SUBJECT: Yuba River Development Project

FERC Project No. 2246-058

Study 6.1, Riparian Habitat Upstream of Englebright Reservoir Study

Large Woody Debris Survey Sites

Figure 2: Map of potential LWD study areas in the Middle Yuba and Oregon Creek, created by NMFS.

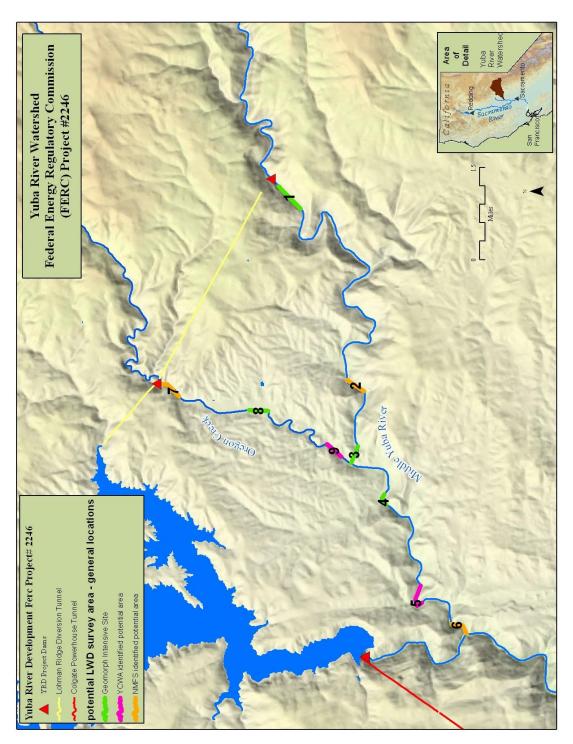
As a result of these conferences, YCWA understands that FERC and the NMFS would consider this disputed item resolved if the Study was modified to state that a total of nine sites, each site approximately 20 times bankfull width in length, in the Middle Yuba River and Oregon Creek would be surveyed for LWD. The sites include four sites identified for geomorphic surveys per the Channel Morphology Upstream of Englebright Reservoir Study (Study 1.1), and five other sites. The approximate location of the nine sites is shown in Attachment 1 to this letter.¹

This letter states YCWA's support of adding the above nine sites to the Study, assuming they can be accessed safely - and <u>if</u> this resolves the disputed item regarding LWD surveys, including sites, methods for surveying and reporting regarding LWD.
